Access Compliance Report

Public Rights-of-Way

Intersection ID: 10036062	Main Street: RIVERGATE_PY	Cross Street: N/A	Location: S
ADA ID: CFD962B10211	Ramp Type: PerpDiag	Initial Pass/Fail: Fail	Overall Compliance: No
		Severity Score: 12.5

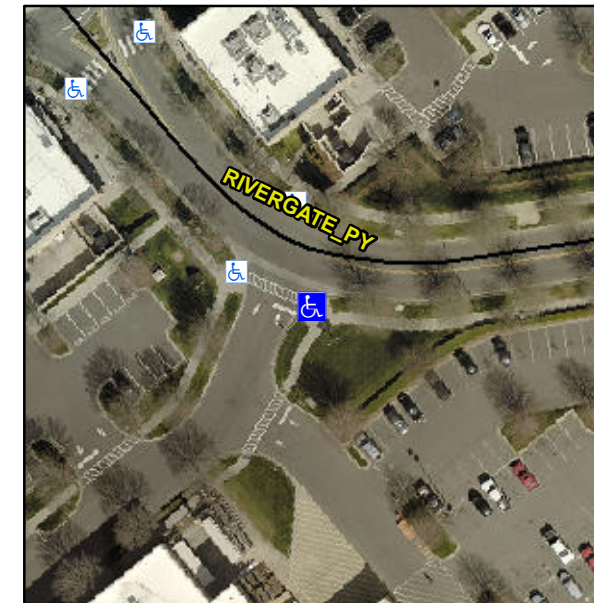
Not Found, R304.5.3

Compliance	Description	Data	Compliance	Description	Data
N/A	Ramp Length (in)	95.0	Yes	Ramp Slope (%)	5.9
Yes	Ramp Width (in)	54.0	No	Ramp XSlope (%)	6.5
N/A	Flare Type LT	N/A	N/A	Flare Type RT	N/A
N/A	Flare Slope LT (%)	N/A	N/A	Flare Slope RT (%)	N/A
N/A	Flare Traversable LT?	N/A	N/A	Flare Traversable RT?	N/A
N/A	Landing Length (in)	N/A	N/A	DWS Provided?	N/A
N/A	Landing Width (in)	N/A	N/A	DWS Contrast?	N/A
N/A	Landing Slope (%)	N/A	N/A	DWS Length (in)	N/A
N/A	Landing X Slope (%)	N/A	N/A	DWS Full Width?	N/A
N/A	Landing Curb? (Y/N)	N/A	N/A	DWS Offset (in)	N/A
N/A	Shared Landing?	N/A			
N/A	Gutter Ponding?	N/A	N/A	Gutter Slope (%)	N/A
N/A	Gutter Lip Ht (in)	N/A	N/A	Gutter X Slope (%)	N/A
N/A	Painted X Walk1?	No	N/A	Painted X Walk2?	Yes
	X Walk 1 Direction	To NE		X Walk 2 Direction	To NW
N/A	X Walk 1 Width (in)	N/A	N/A	X Walk 2 Width (in)	62.0
	X Walk 1 Slope (%)	3.0		X Walk 2 Slope (%)	3.0
	X Walk 1 X Slope (%)	3.7		X Walk 2 X Slope (%)	2.3

Remove & Replace Curb Ramp With Two New Directional Ramps or Equivalent.
